**BEFORE THE BOARD OF PATENT APPEALS  
AND INTERFERENCES**

Application Number: 10/698,867  
Filing Date: October 30, 2003  
Appellant(s): PASKALOV ET AL.

**EXAMINER'S ANSWER**

As shown in Applicants' Fig. 1:

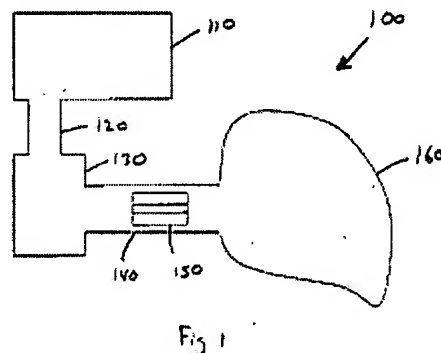
However, there is sufficient written description for flowing the waste into conduit **140** where it is carried past the waves of the RF plasma generator **150** (page 4, lines 22-23). The conduit, which is substantially water tight, carries the fluid waste past the waves allowing it to be **subjected to the waves** for an amount of time that is sufficient to inactivate or kill a substantial amount of the microorganisms in the waste (page 5, lines 5-8).

the conduit **140** carries the waste in the vicinity of the RF plasma wave generator **150**. The waste would have been subjected directly to the waves produced by the RF plasma generator **150**.

FIG. 1

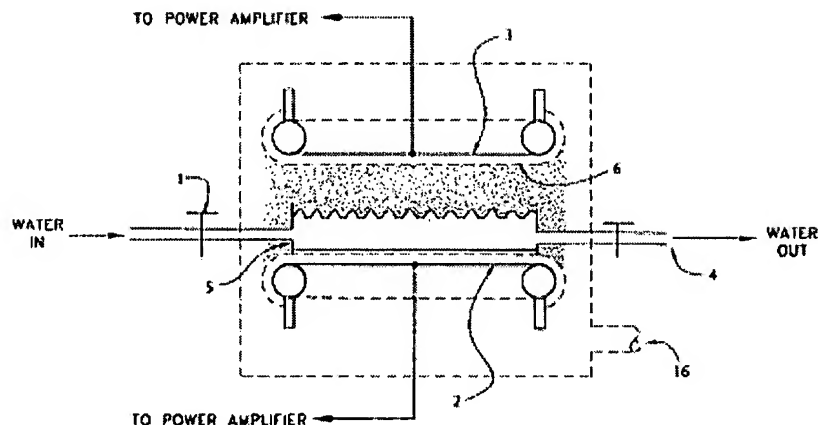
without subjecting the waste directly to a plasma generated by the RF plasma wave generator (= the water is exposed to **irradiation** for a period of time) [col. 1, line 67 to col. 2, line 2; col. 4, lines 54-55; and Fig. 1:

reference character **5** is shown as **a closed container**].
